# CITY OF ALBUQUERQUE

RE: **ABQ Ride Daytona Transit Facility**  
**Grading and Drainage Plan (Engineer's Stamp Date: 6/14/17)**  
**Coversheet Stamp Date: 6/1/17**  
**Hydrology File: J09D025**

Based on the information provided in your submittal received on 6/23/17, the Grading and Drainage Plan cannot be approved for Building Permit until the following comments are addressed:

DESIGN REVIEW COMMITTEE		CITY ENGINEER APPROVAL		MO./DAY/YR.		MO./DAY/YR.	
City Project No. COA 5658.05		Zone Map No. J-09-Z		Sheet C-7

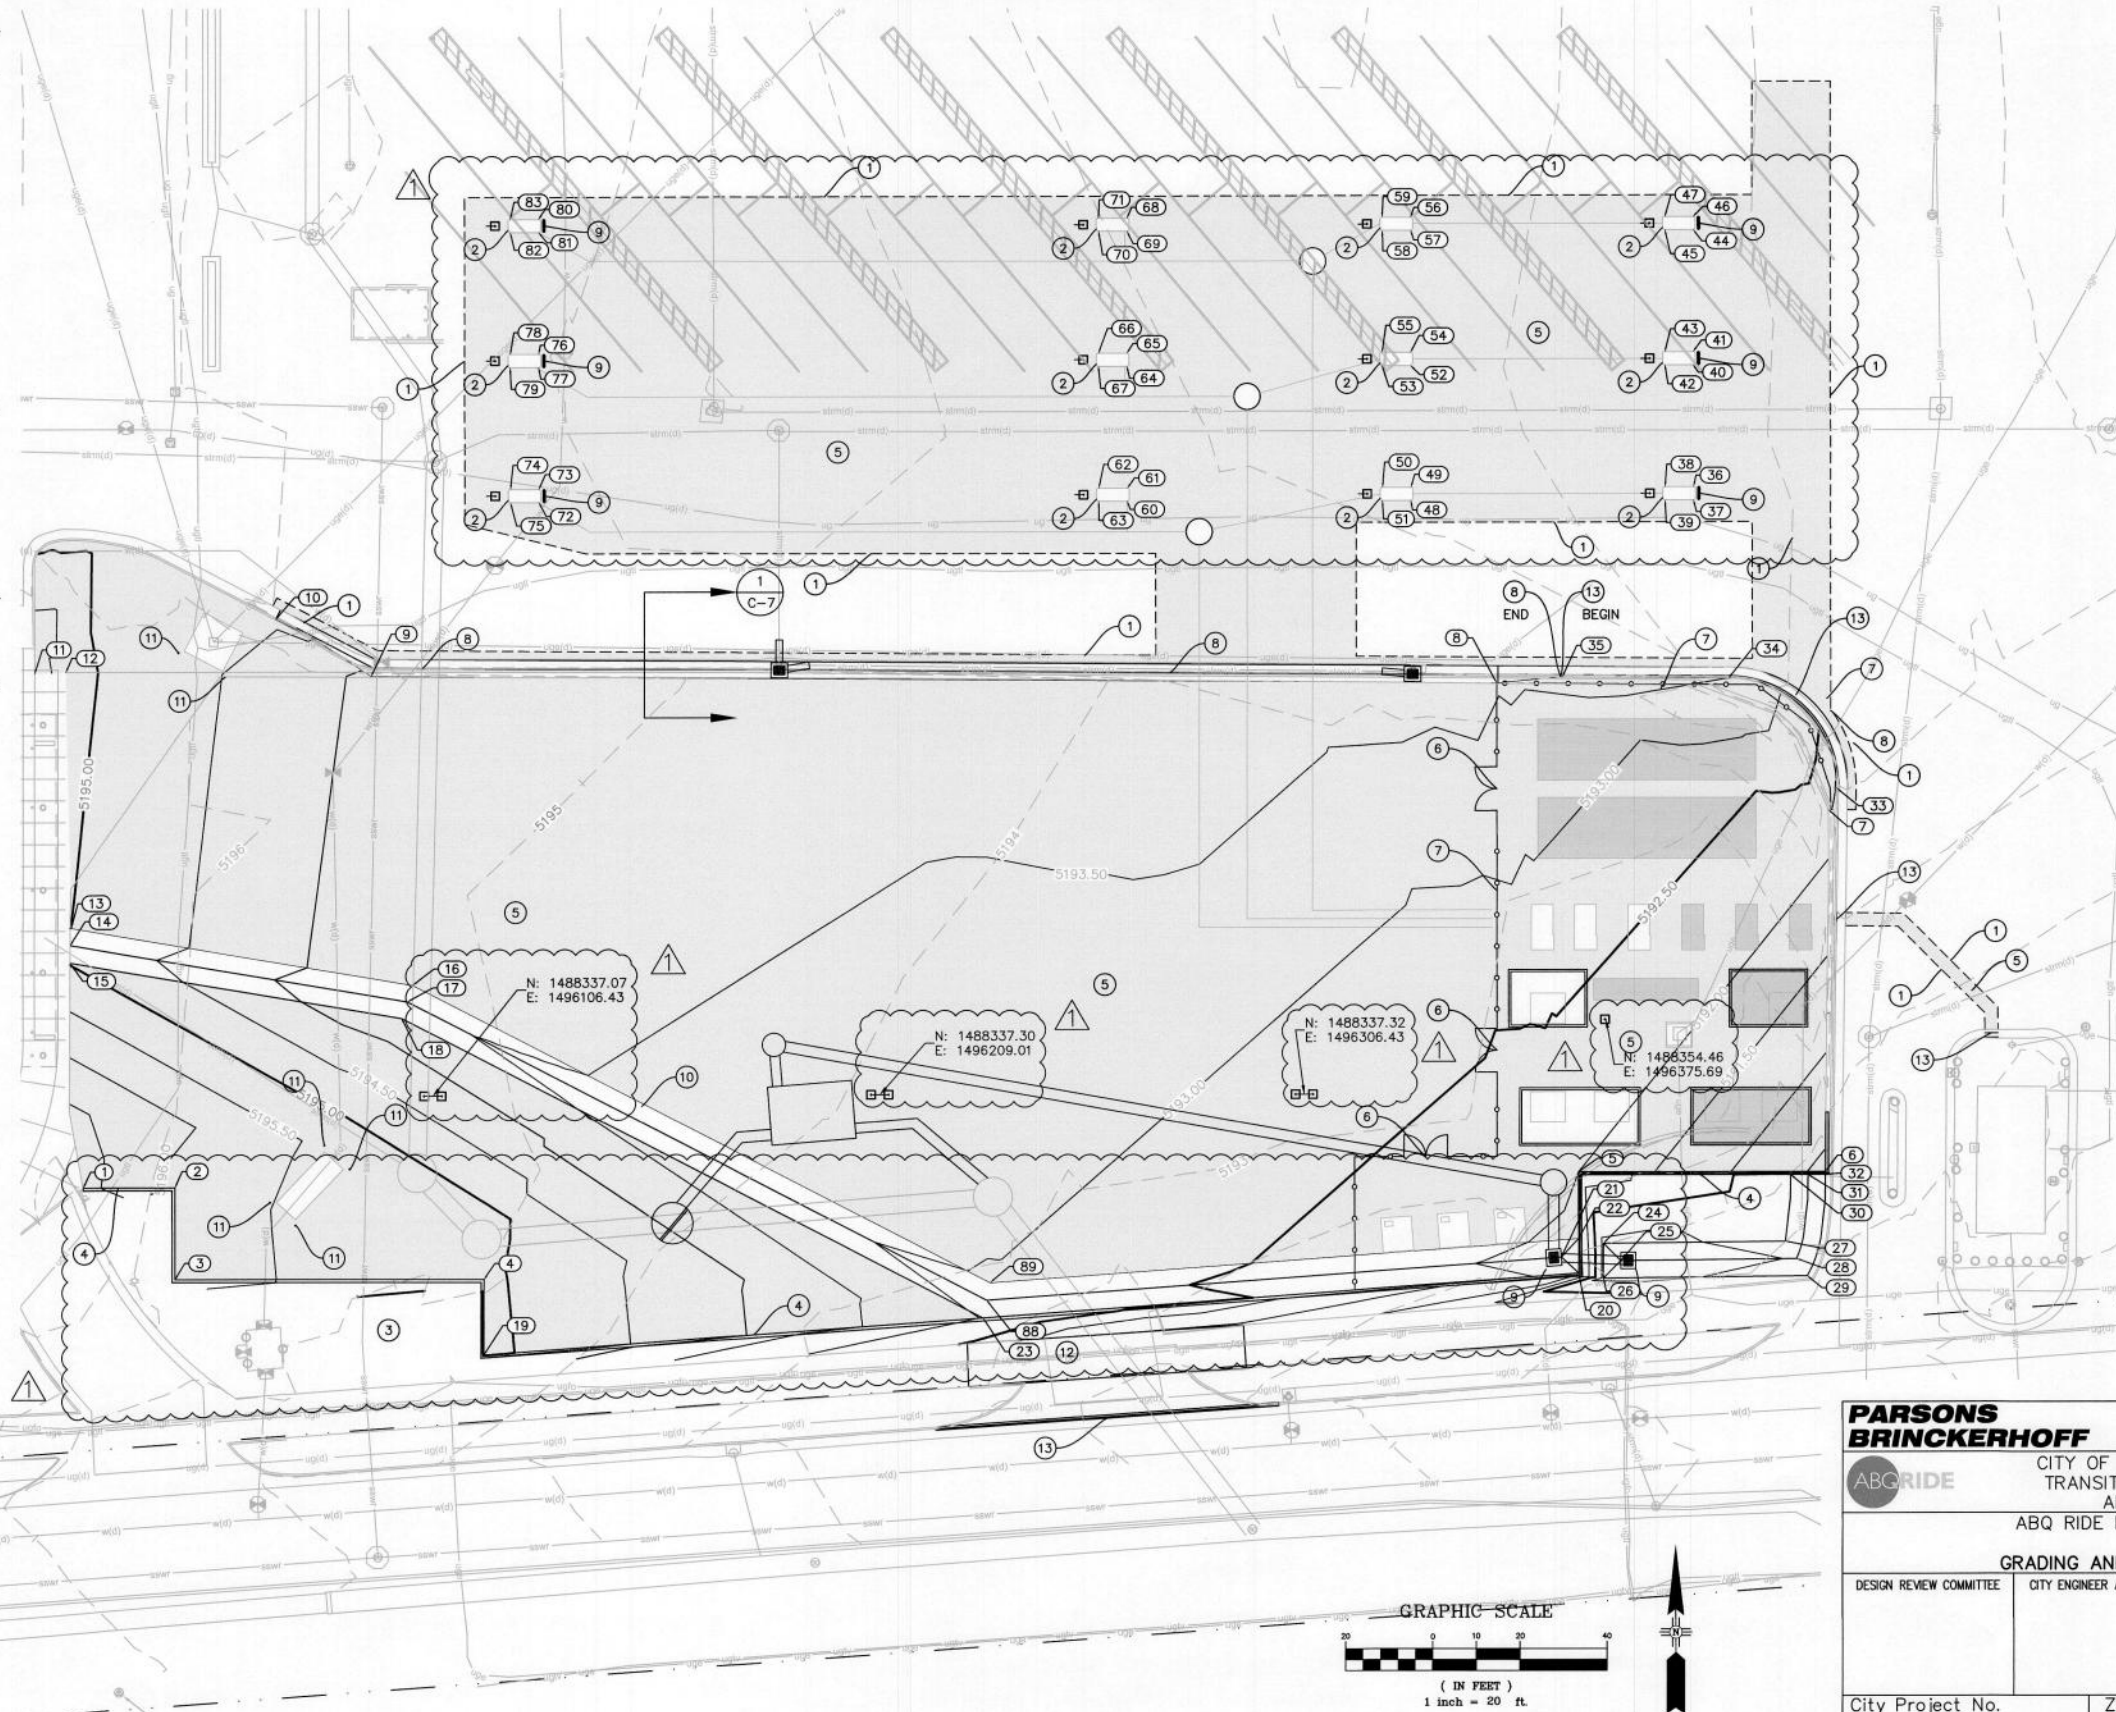
1. How are the depressed ponding areas in the landscape buffers being built? There are details provided, but they are not called-out anywhere. The grading plan does not include grading to create these areas, and the landscaping sheets don't show any depressed areas or call-outs to create them.

<b>PARSONS BRINCKERHOFF</b>		CITY OF ALBUQUERQUE TRANSIT DEPARTMENT ABQ RIDE ABQ RIDE DAYTONA DESIGN	
PROPOSED STORM DRAIN PLAN			
DESIGN REVIEW COMMITTEE	CITY ENGINEER APPROVAL	MO./DAY/YR.	MO./DAY/YR.
City Project No. COA 5658.05	Zone Map No. J-09-Z	Sheet C-9

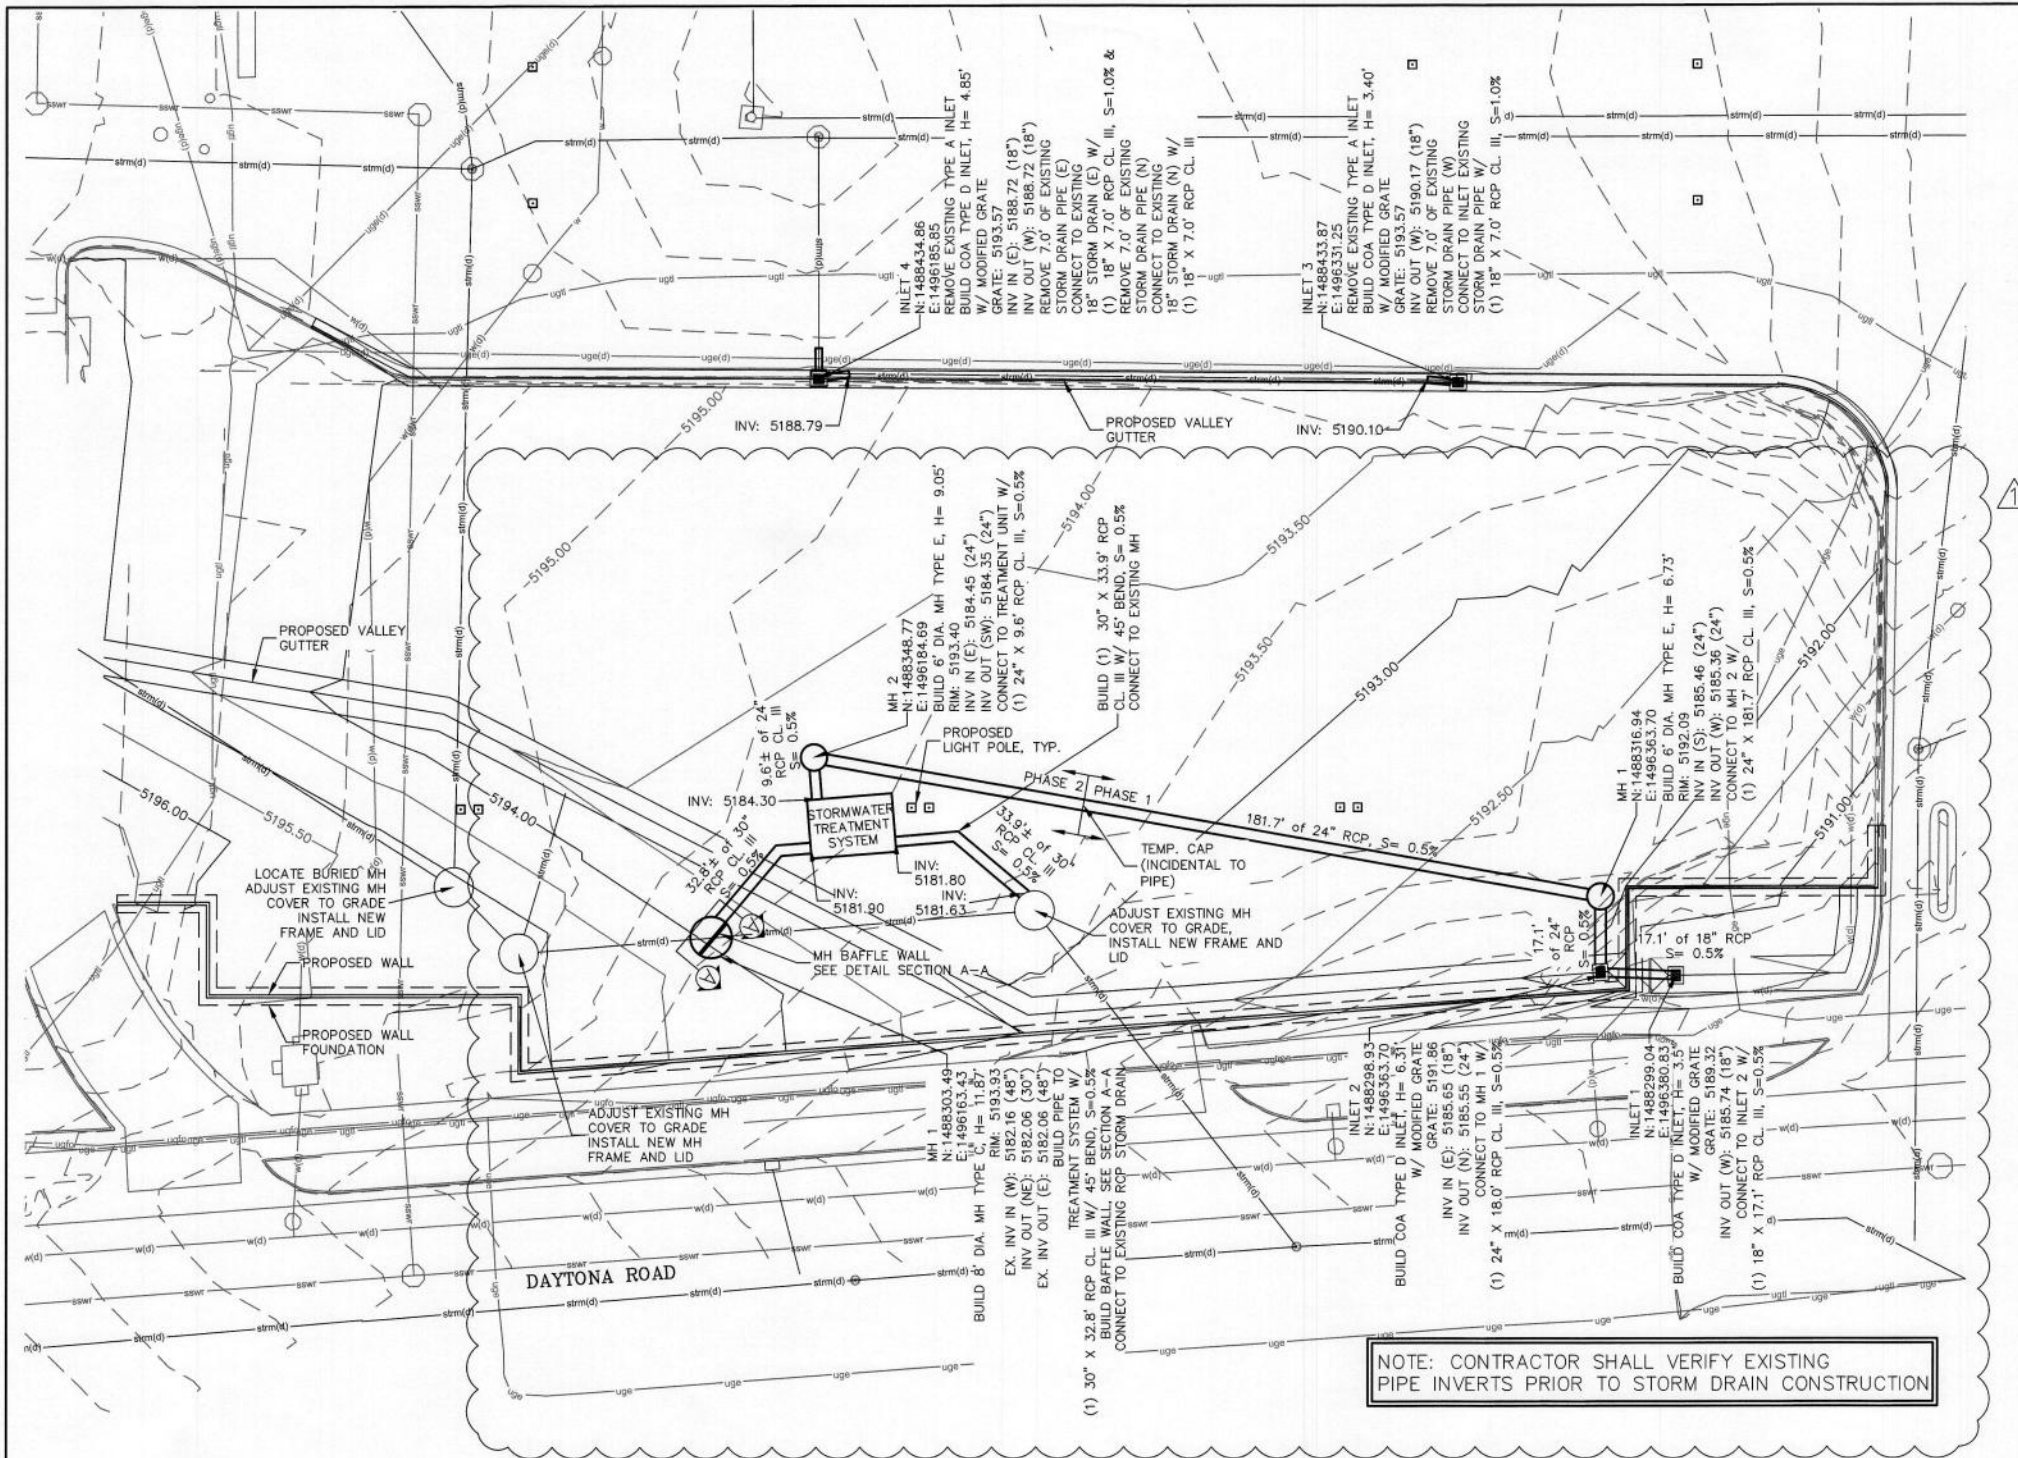
3. Pipe profiles and supporting data need to be included: flow (100yr), velocity, HGL, and junction losses through the various manholes and water quality features.

4. Is the 25cfs rating on the Stormwater Treatment System sufficient to treat the Q100 or the first flush volume? The SPCC plan should govern its sizing. Please provide a typical detail for the Stormwater Treatment System.
